Project Number: O-E8982-00-04

RE: Public review comments on the Environmental Report for the Enerdu GS Expansion and Redevelopment Project

Figure 1. Zones of influence – EA vs. current operations at the Enerdu GS

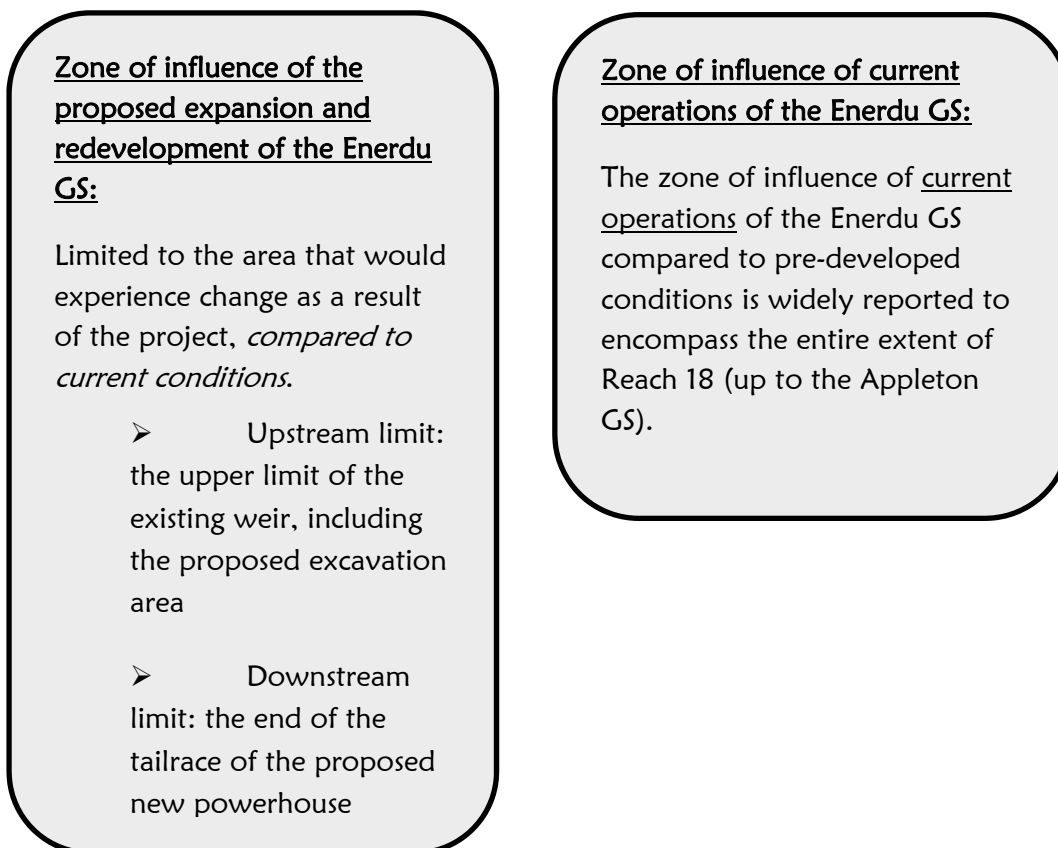
The EA is intended to assess the potential impacts associated with the proposed expansion and redevelopment of the Enerdu GS; that is, *existing conditions* were compared to what may occur if the project proceeds. Since the proposed upgraded facility would continue to adhere to the Mississippi River Water Management Plan (MRWMP) as it currently exists, no changes to water levels between the Enerdu GS and the Appleton GS (i.e. Reach 18) would occur as a result of the proposed project redevelopment. The zone of influence of the proposed project itself therefore spans from the proposed excavation area near the upper limit of the existing weir, down to the tailrace of the proposed new powerhouse. Since the scope of the EA focused on the areas that would experience change due to the proposed project, the study area for the EA (including the natural heritage component of the EA) was generally focused on the immediate project area, rather than extending 9 km upstream to include the Appleton wetland and the tailrace of the Appleton GS and 15 km downstream to include the Galetta GS.

Figure 1 illustrates the difference between 1) the Zone of Influence of the proposed Enerdu project and 2) the Zone of Influence of current operations at the Enerdu GS compared to pre-developed conditions.
